M1985-184 - Bivens Pit- TR-2: 2nd Submission and Comments to Adequacy Review

**Subject: Bivens Trucking and Excavating, Inc –
Bivens Pit, Permit No. M-1985184
Response to Adequacy Review on Technical Revision 2**

Telesto Solutions, Inc. (Telesto) submits this letter on behalf of Bivens Trucking and Excavating, Inc. (Bivens) to address comments and questions in Adequacy Review No. 1 (AR-01) dated January 8, 2021. We appreciate your time in this matter. This letter repeats the comment/question from the adequacy review in *italics* with a response immediately following. Responses and questions that led to a change in Technical Revision 2 (TR-02).

FIGURE 1
SITE LAYOUT

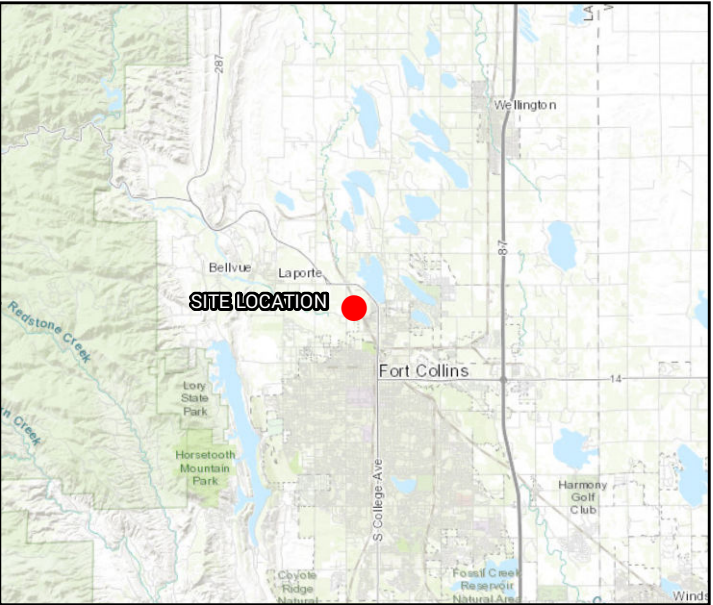
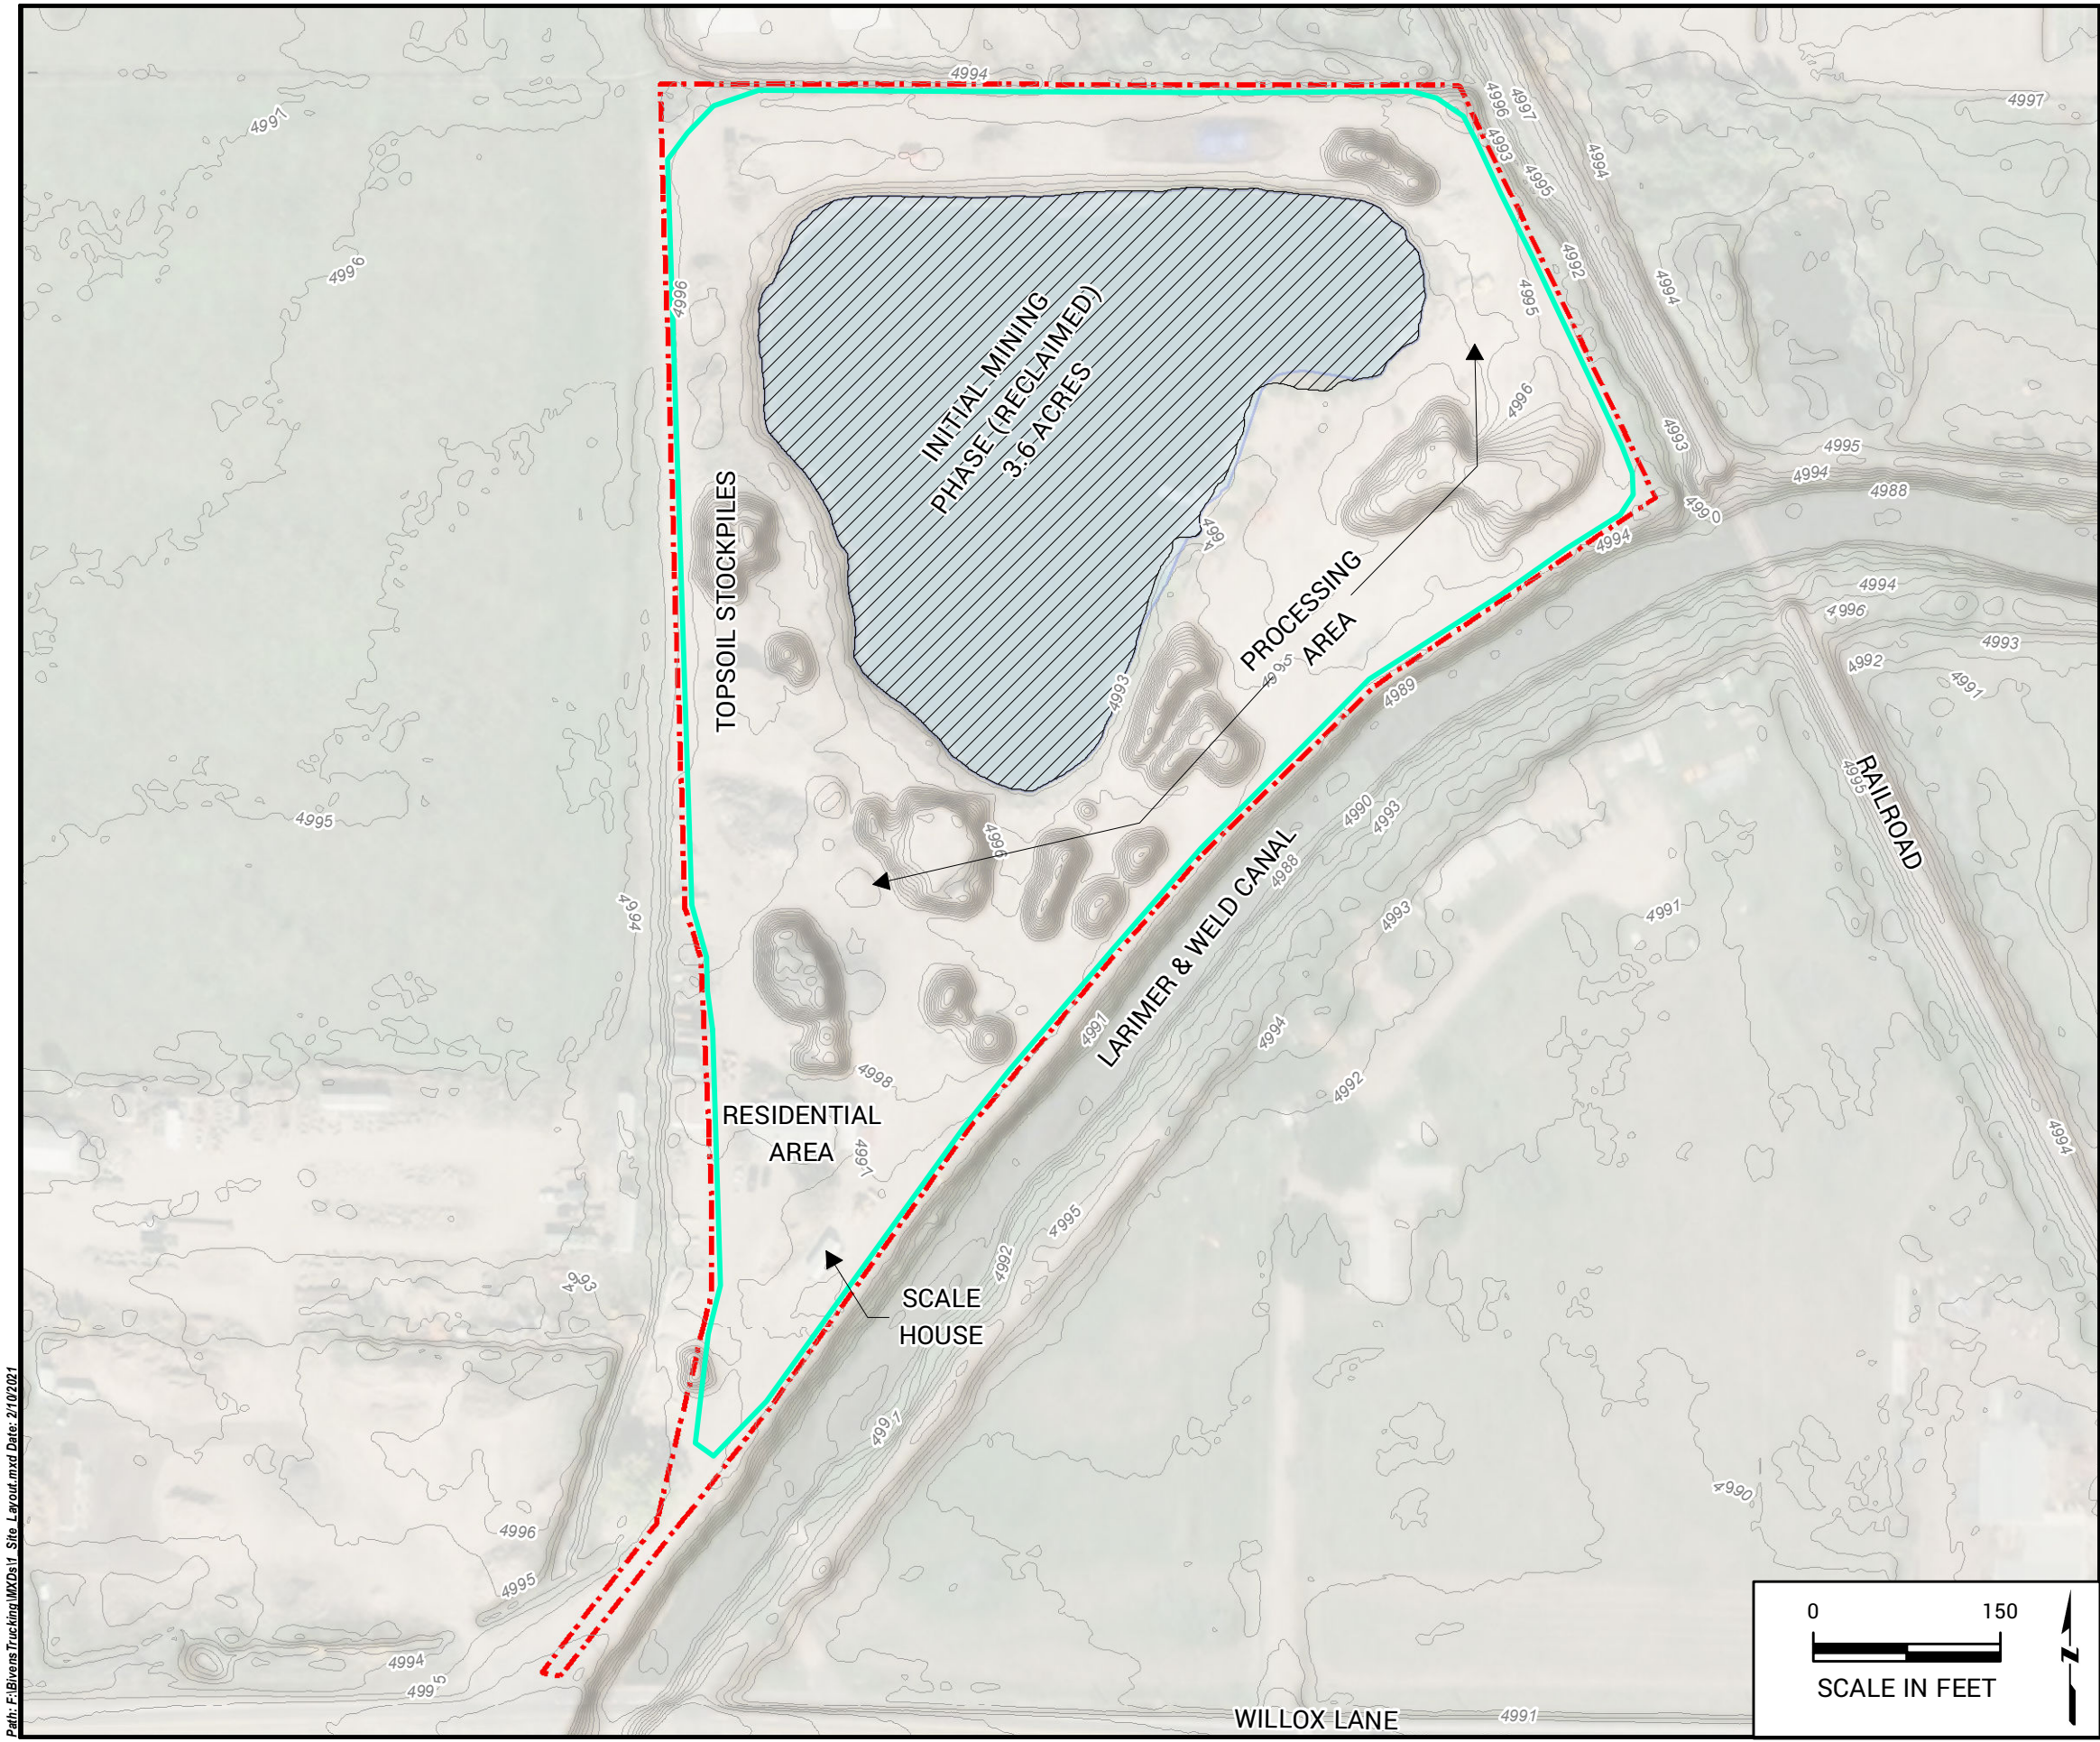
On Figure 1 – Site Layout, the legend shows the permitted disturbance area to be 11.1 acres. Please be advised, the allowed disturbance cannot exceed the approved permit area, which is 11 acres in this case. Please adjust this acreage amount accordingly.

The disturbance area has been adjusted to the approved permit area of 11 acres.

FIGURE 4
PLAN 1 - POST MINING LAND USE & RECLAMATION
PLAN

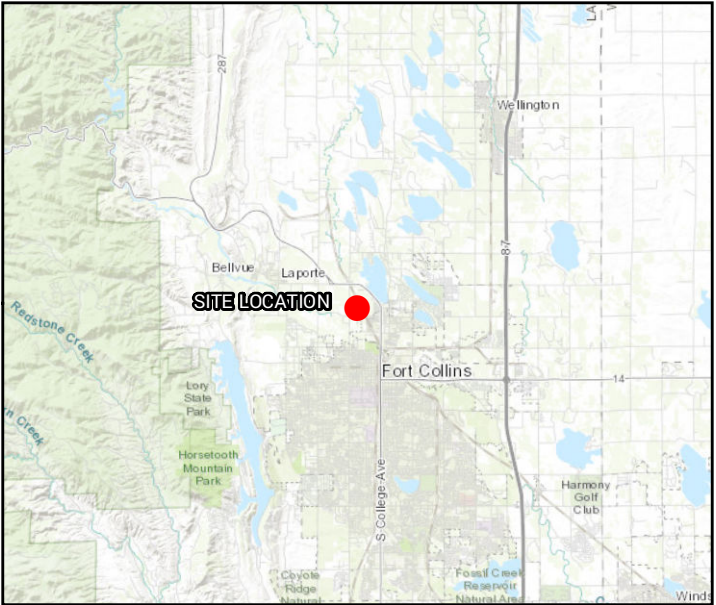
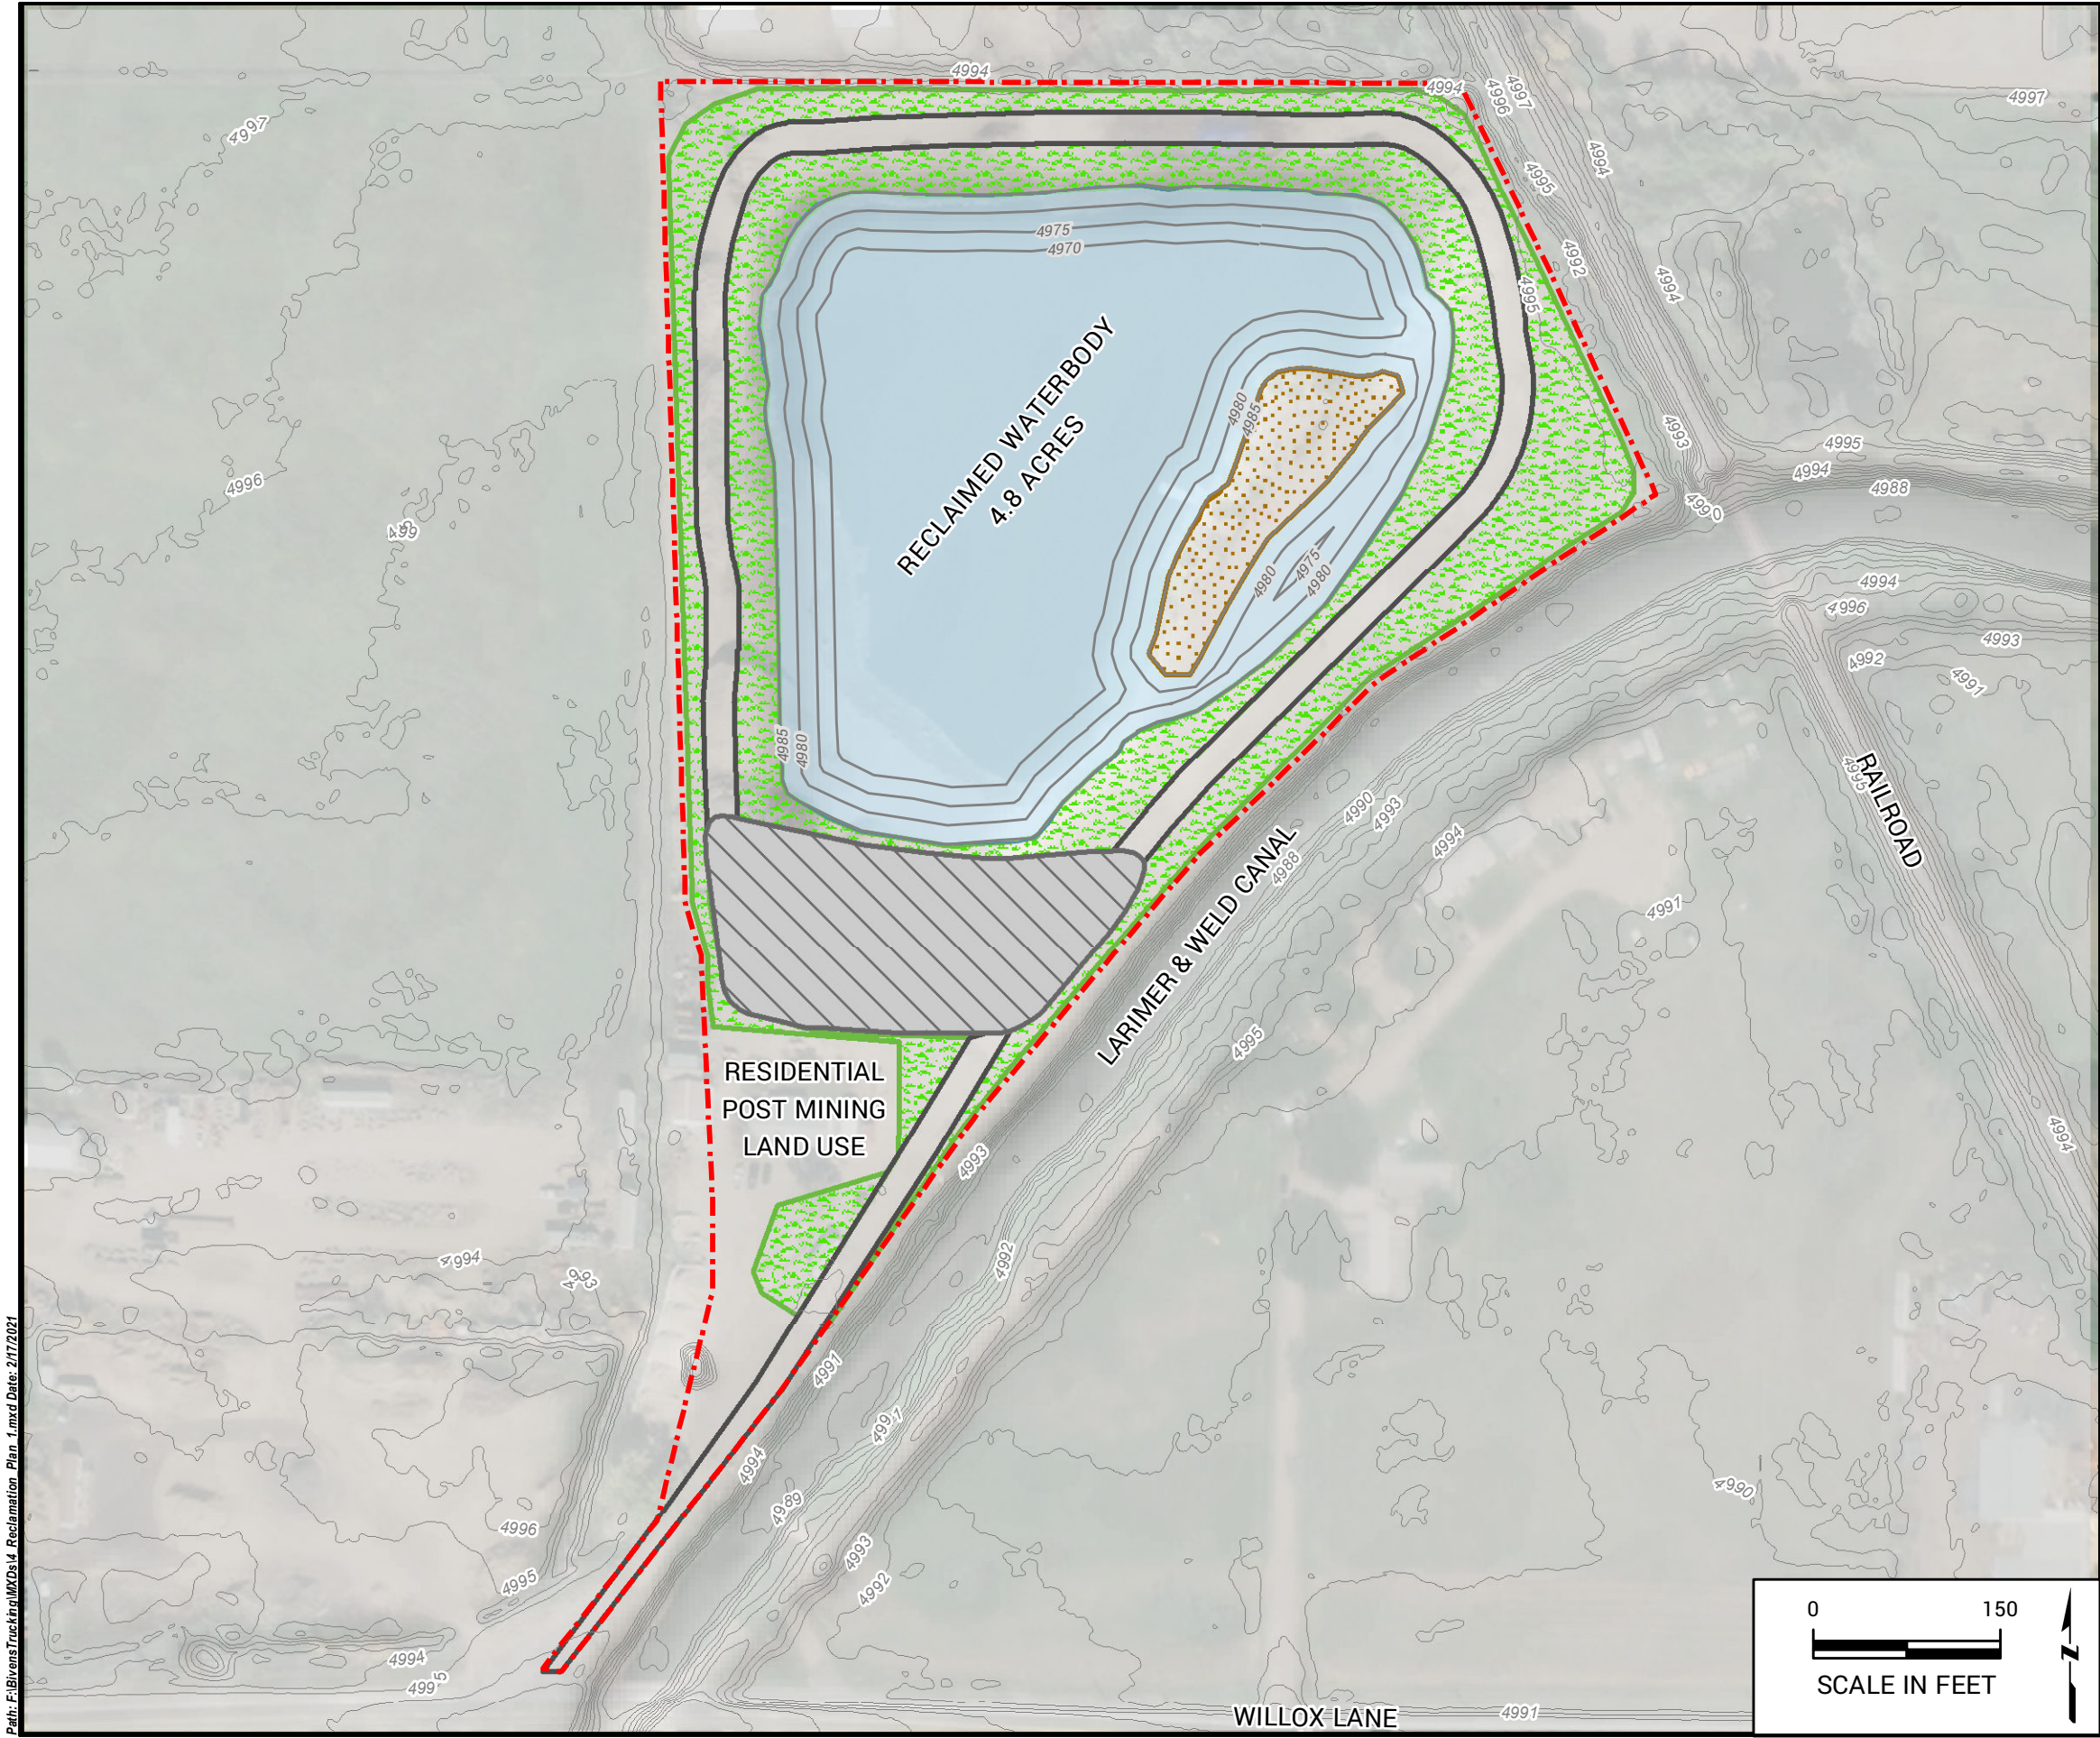
The updated reclamation plan proposes two separate scenarios for final reclamation. One plan includes leaving a 4.6 acre pond (per the text; 4.9 acre pond per Figure 4) with a 0.4 acre recreational area, a 1.3 acre parking area (to receive 6 inches of road base), 1.3 acres of roads (to receive 6 inches of road base), and an area of 2.7 acres to be retopsoiled at 12 inches depth and revegetated. The other plan includes all the same features except that a water feature of unspecified size may be excavated between the recreational area and the proposed parking area and this material will be used to backfill an unspecified portion of the expanded pond.

On Figure 4 – Post Mining Land Use and Reclamation Plan, features from both of the proposed reclamation plans are shown on this map, including the potential water feature and the potential pond backfill area (from the 2nd proposed reclamation plan). Please provide a separate reclamation plan map for each of the proposed reclamation plans showing how each portion of the affected lands will be reclaimed for each of the proposed plans, including the correct acreages. While the operator will have the option of choosing which reclamation plan to implement at the site (after TR-02 approval), the Division must calculate the required financial warranty based on the most costly reclamation plan proposed, in the event the permit was revoked and the State had to complete reclamation of the site. Alternatively, the operator could commit to one reclamation plan, and modify Figure 4 accordingly.

We have clarified that the “water feature” is not part of reclamation, but rather there are two options to end mining (one with an island and one without). We have provided the data requested to calculate the bond under both closure scenarios in the updated technical revision. Based on the amount of reclamation completed to date, we believe the existing bond should cover either scenario. We have not calculated the required bond as the Division typically does this internally, but we can if so requested.

Bivens proposes two final reclamation plans, Plan 1 and Plan 2. Both final reclamation plans include additional figures made to match quantities provided in Item 5. Please refer to updated TR-02 for the details of the two reclamation plans.
